RE: PCN # ESW490-32 -- TO-218 & TO92 & APAK Package Alternate Molding Compound for Thyristor and SIDACtor

Product/Process Change Notice (PCN)

PCN#: ESW490-32 **Date:** Apr 15th, 2019

Approve new molding compound for all TO-218 & TO92 & APAK package products of Thyristor and SIDACTor.

FIG 1. TO218 Package Product Appearance

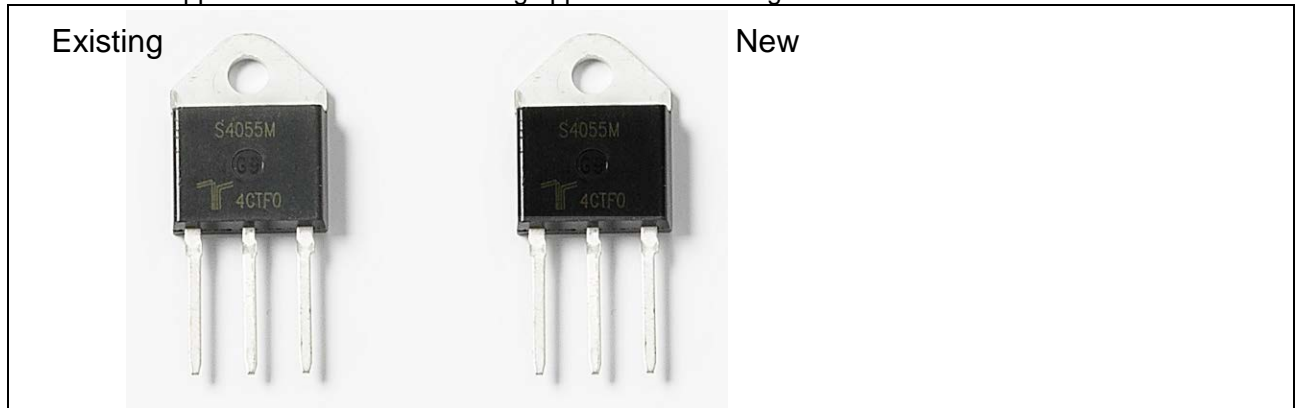
Product appearance and laser marking appearance is changed.
